Standardized Nuclear Unit
Power Plant System

July 8, 1983

SLNRC 83-0036 FILE: 0543
SUBJ: SNUPPS Technical Specifications

FIGURE 3.1-1 ROD GROUP INSERTION LIMITS VERSUS THERMAL POWER FOUR LOOP OPERATION

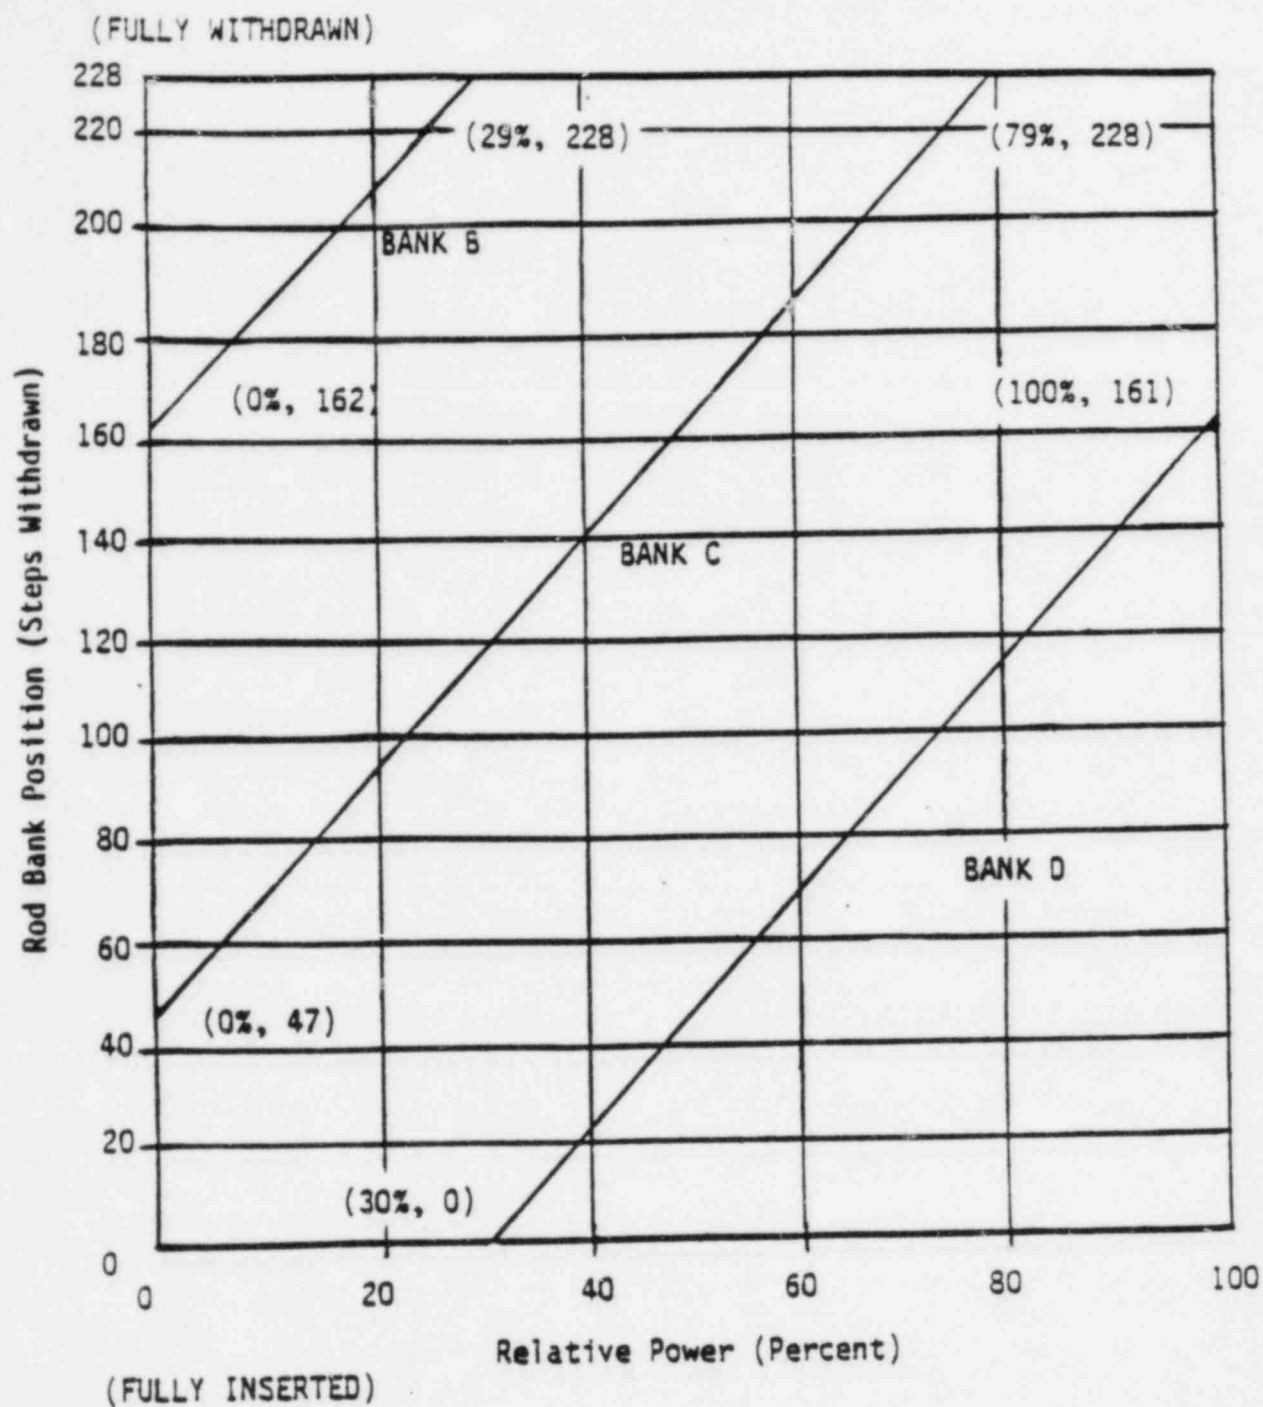
The correct Control Bank Insertion Limits Figure 3.1-1 is attached.

This figure has been revised to reflect the mechanical limitation to no less than a 113 step overlap for control banks. The 115 step difference in the insertion limits for the end points of the rods provides a minimum bank overlap of 113 steps.

FIGURE 3.4-2 WOLF CREEK REACTOR COOLANT SYSTEM HEATUP
LIMITATIONS APPLICABLE UP TO 16 EFPY

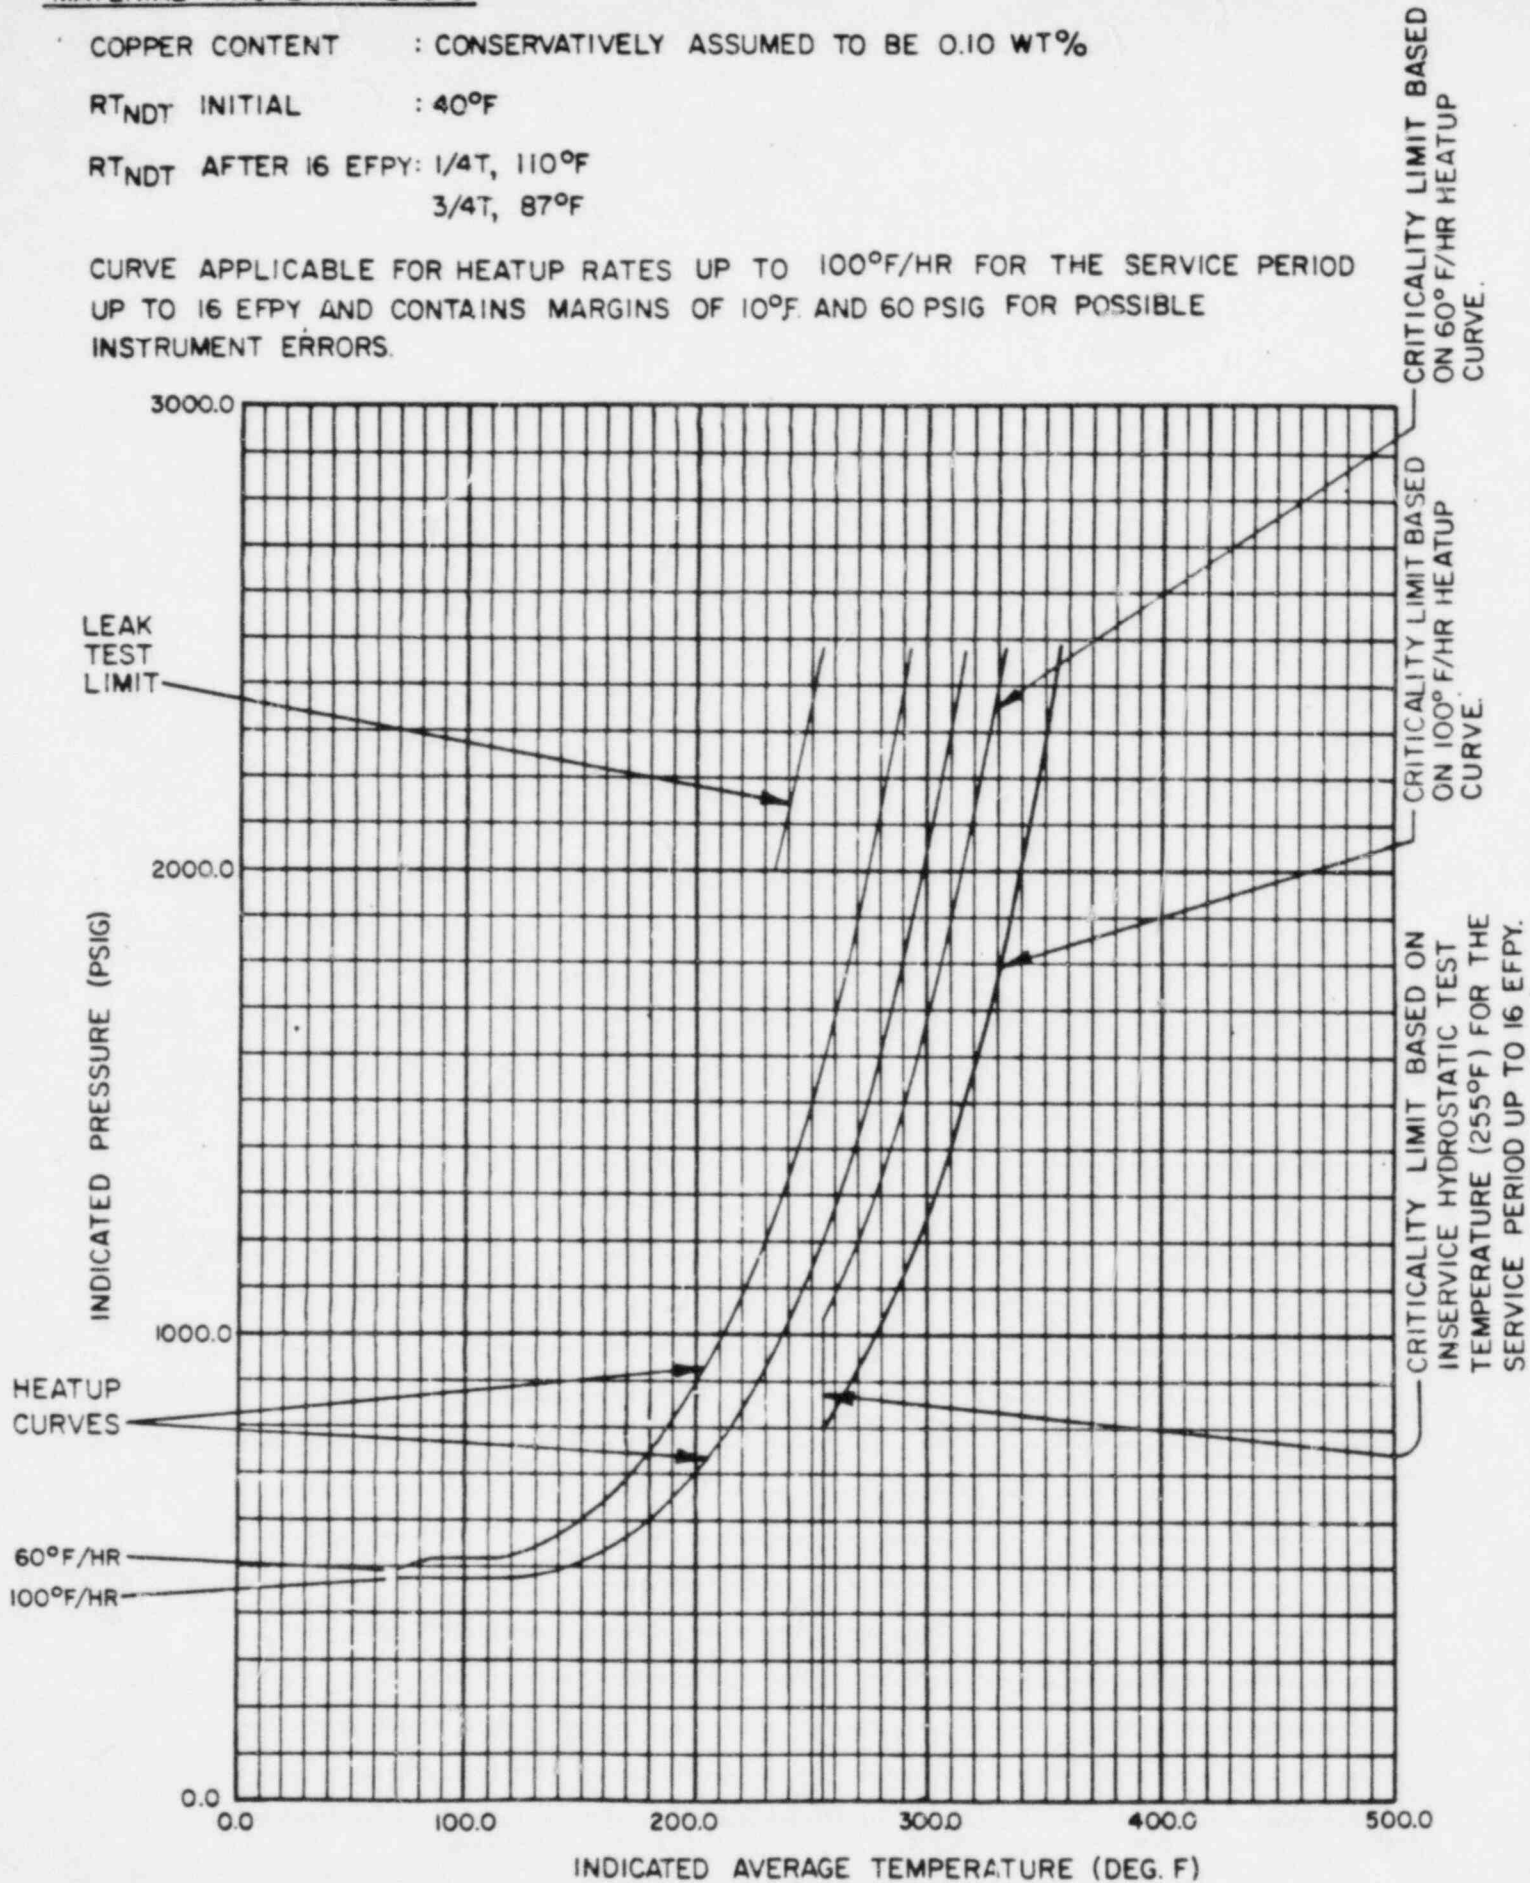
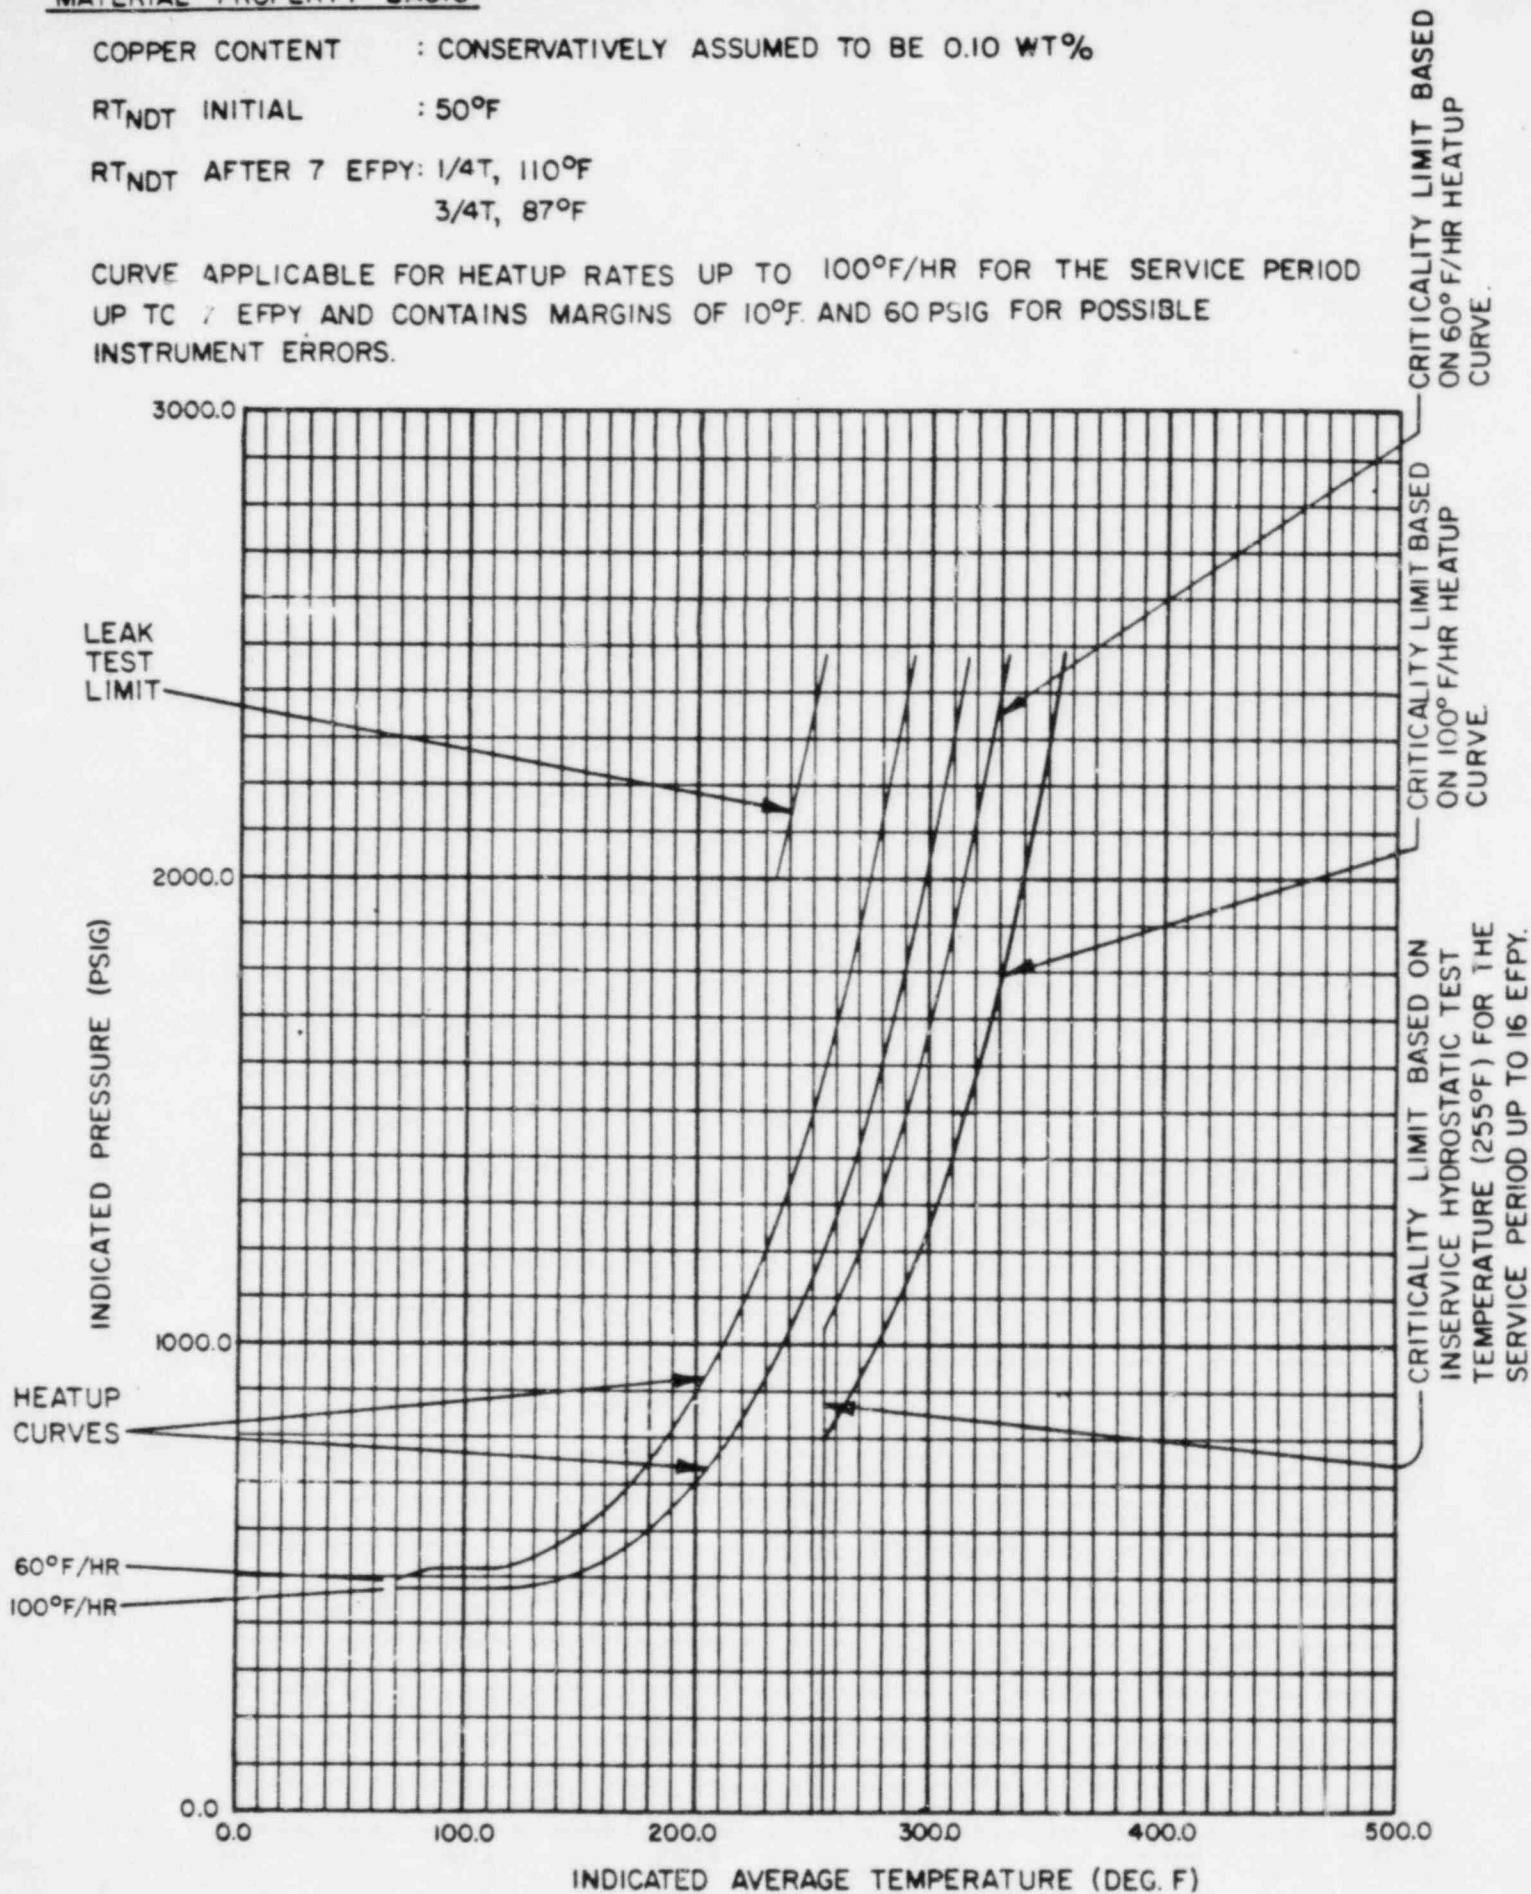
The attached curves have been modified to reflect the addition of a 100°F/hr heatup curve and (Figure 3.4-2) replace any existing Tech Spec figures. Curves for both 60°F/hr and 100°F/hr are included for both Wolfcreek and Callaway.

FIGURE 3.4-4

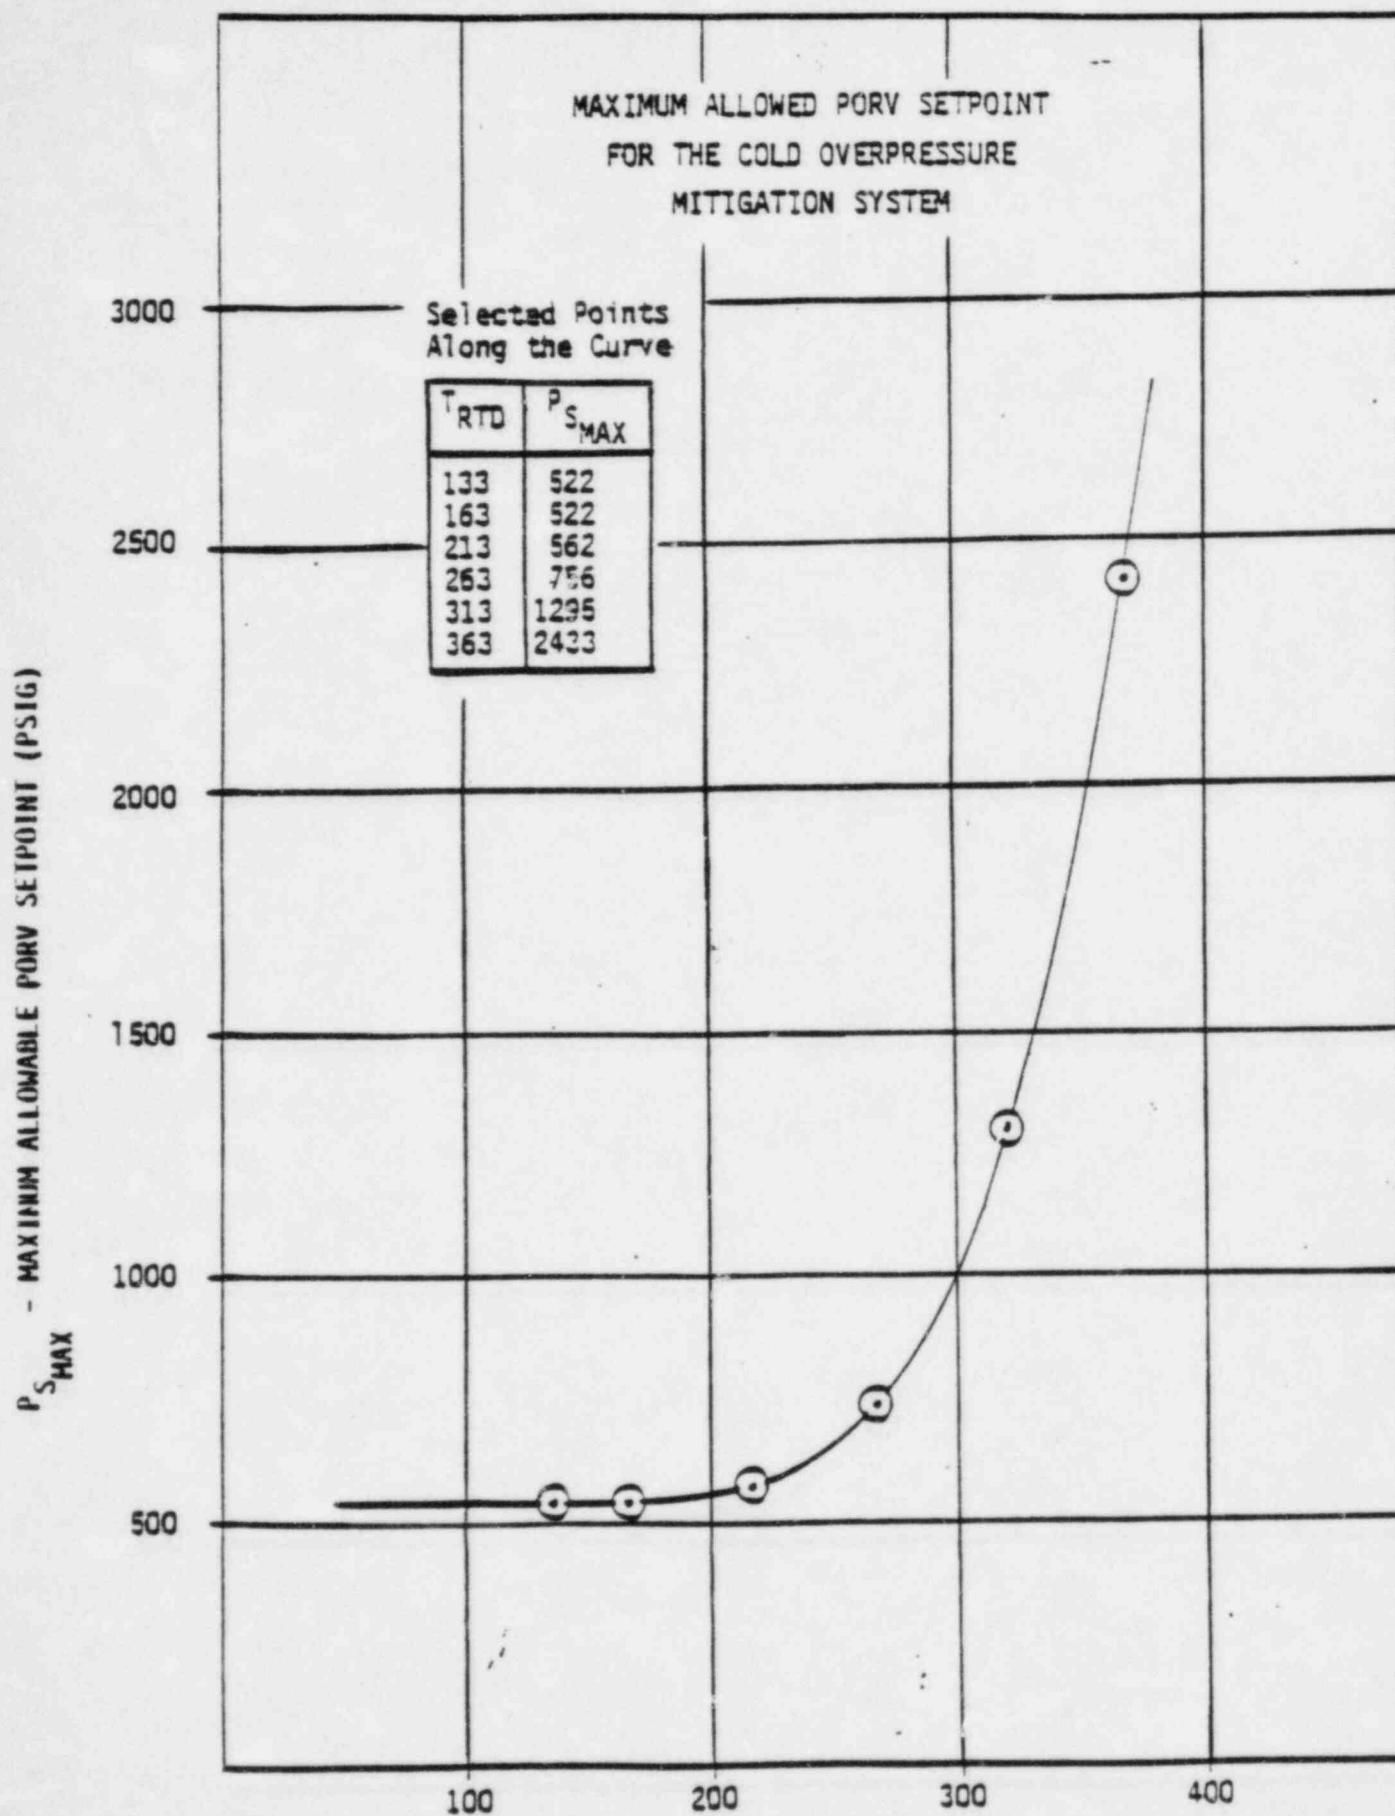
The PORV setpoint limit for COMS is specified by Figure 3.4-4. Vents are more appropriately specified by a flow rate requirement than a vent area.
